# UNITED STATES PATENT AND TRADEMARK OFFICE

## Office Action Summary

10/553,132

## **DETAILED ACTION**

FIG. 10

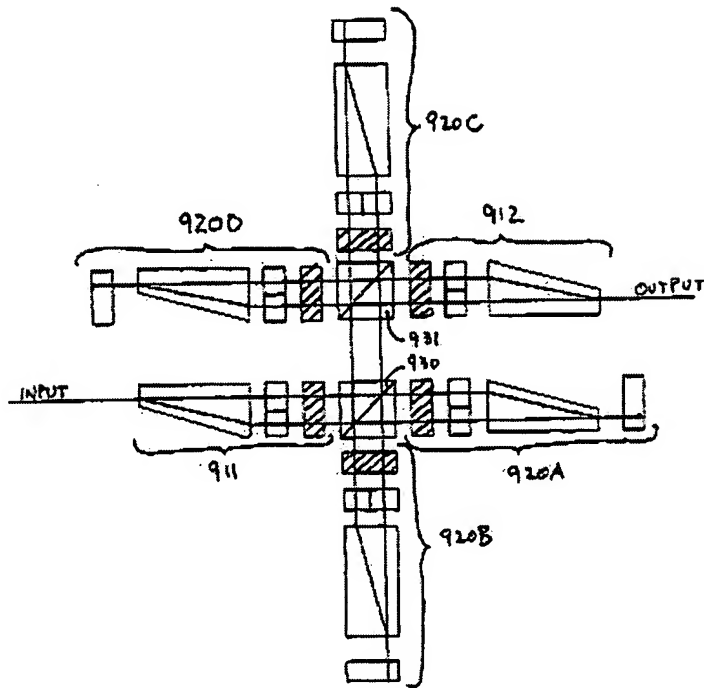
6. As to claim 13, Zhang discloses an optical device (see figure 10) comprising a first combination of birefringent prisms with parallel optic axes (see figure 10, elements 911 and 912) for dividing an input beam into polarized beams (see column 19, lines 27-67, column 20, lines 1-6 and column 21, lines 1-34), a second combination of birefringent prisms with parallel optic axes (see figure 10, elements 920A and 920D) for combining polarized beams into an output beam (see where the two polarized beams travel through birefringent prism 920A toward the etalon and where the two polarized beams travel through birefringent prism 920D toward the etalon), and a polarization changer disposed between said first combination of birefringent prisms and said second combination of birefringent prisms (see the half-waveplates and Faraday rotators that are part of elements 911, 912 and 920A-D of figure 10).

7. As to claim 14, Zhang in view of Cai disclose a third combination of birefringent wedges (see figure 10, elements 920B and 920C of Zhang) with parallel optic axes disposed between said polarization changer and said second combination of birefringent wedges (see figure 10 of Zhang; it is noted that 920B and 920C are spatially between the pairs of birefringent wedges and the polarization changers).

12. Applicant's arguments filed 11/6/2008 have been fully considered but they are not persuasive. Cai was not replied upon to show a pair of birefringent wedges with parallel optical axes. Zhang disclosed pairs of birefringent crystals with parallel optical axes (see the rejection set forth in section 5 above). Cai was merely relied upon to show that the birefringent crystals of Zhang could be cut to be wedge shaped as illustrated by Figure 10 of Zhang as modified by the examiner and set forth below.
